Application for Licence Amendment

Licence Number	L8803/2013/1
Licence Holder	BHP Iron Ore Pty Ltd
ACN	008 700 981
File Number	INS-0001878 / APP-0032881
Premises	Yarnima Power Station Part of AML70/244 NEWMAN WA 6753
Date of Report	25 June 2026
Decision	Revised licence granted

Figure 2: Maximum predictive 1-hour NO_x ground level concentrations (Scenario 2 – cumulative assessment).

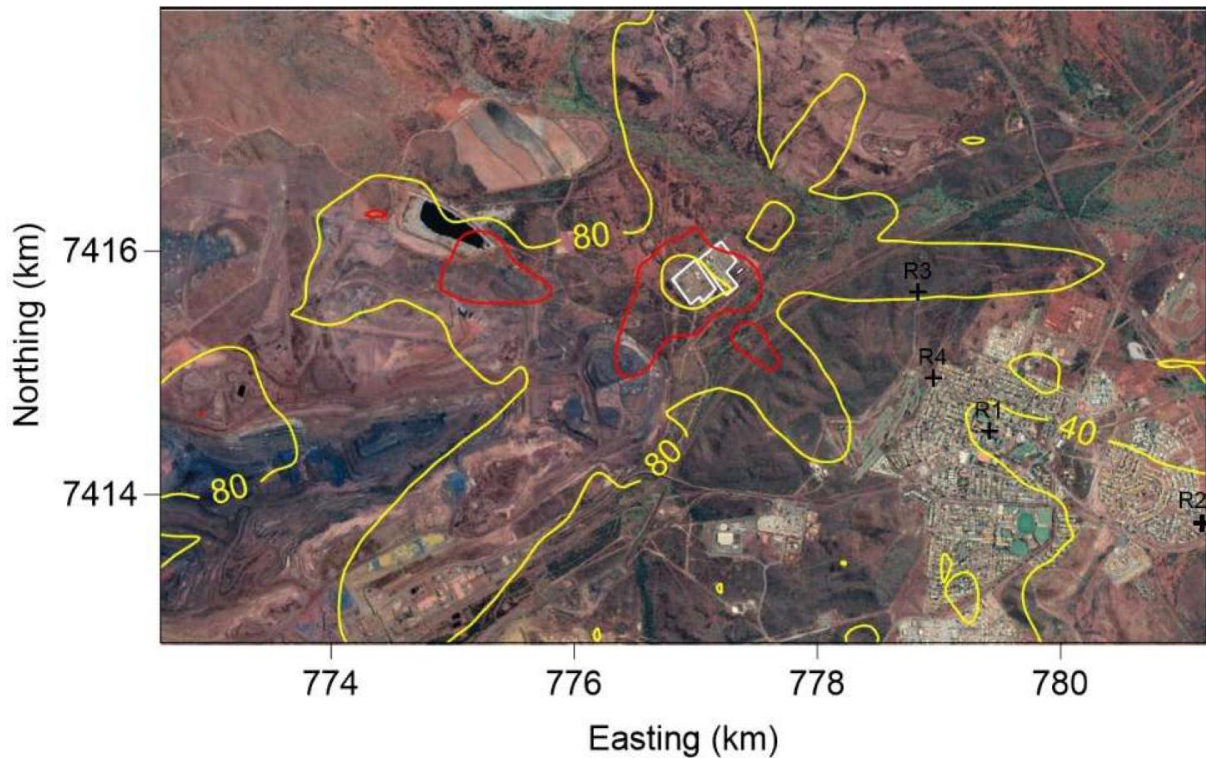
Results of cumulative modelling indicate that the maximum 1-hour NO₂ concentration at modelled sensitive receptors is 41.7µg/m³ at R4 (<28% of the NEPM guideline) (Figure 2). The annual average NO₂ concentrations are predicted to be about 3% of the assessment criteria. Similar results were shown for start-up and emergency conditions with the maximum 1-hour NO₂ concentration predicted to be 42µg/m³ and 36.4 µg/m³ respectively at sensitive receptors. These results suggest a significant improvement in overall air quality associated with the operation of the GREs compared to the diesel engines of the TPS.

Figure 3: Prediction L_{A10} noise levels (dB(A)) with additional noise controls applied.

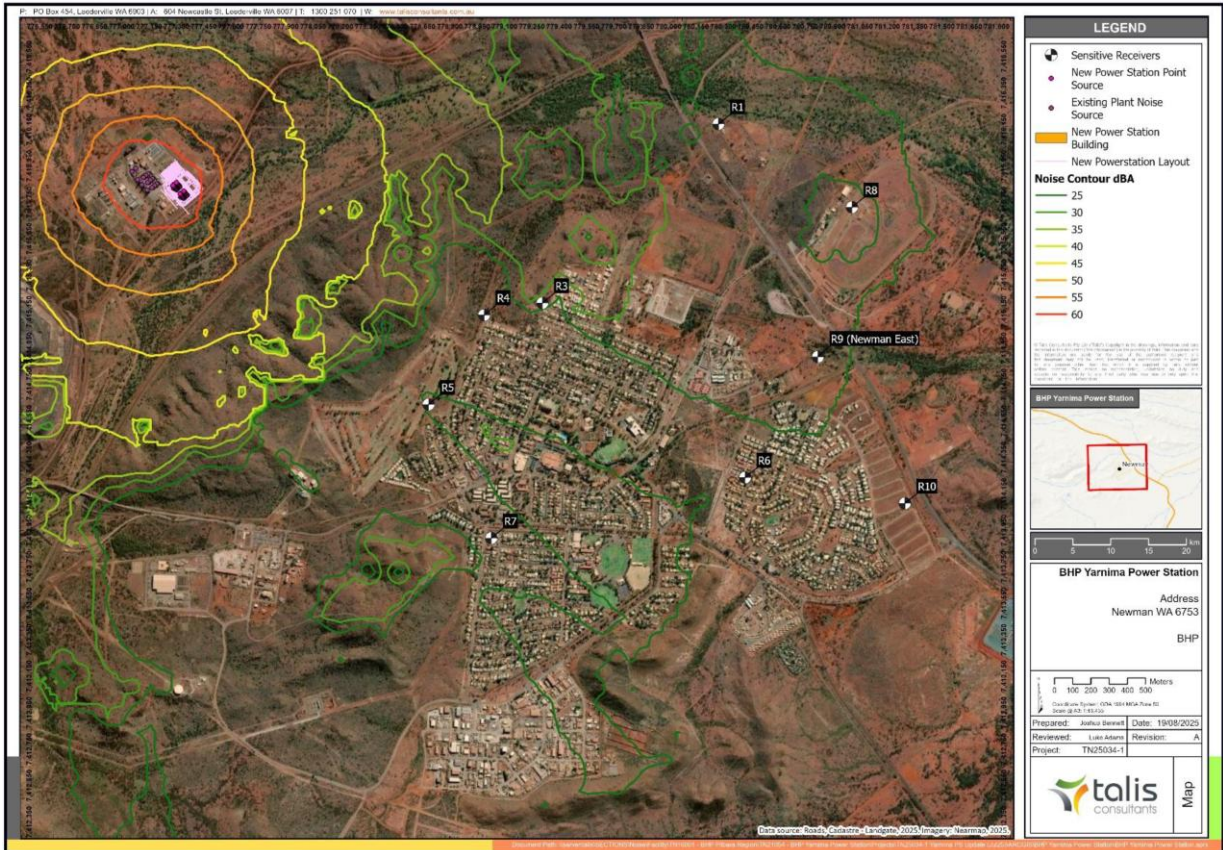
Modelling indicates that with the additional measures in place, the assigned noise levels will be achieved at all modelled sensitive receptors with the maximum L_{A10} predicted to be 29.4dB(A) at those locations; below the assigned noise level of 30dB(A). However, the noise controls do not appear to address the potential exceedance in the residential zone north-east of R3 which is predicted to be between 30-35dB(A) (Figure 3).

Since undertaking the modelling, the Licence Holder has revised the design of the engine halls to achieve further noise reduction such that all facades and the roof will achieve an Rw of 49 (refer to Appendix 1). The Licence Holder has committed to undertaking noise monitoring during commissioning to validate the effectiveness of noise controls and confirm compliance with the Noise Regulations.
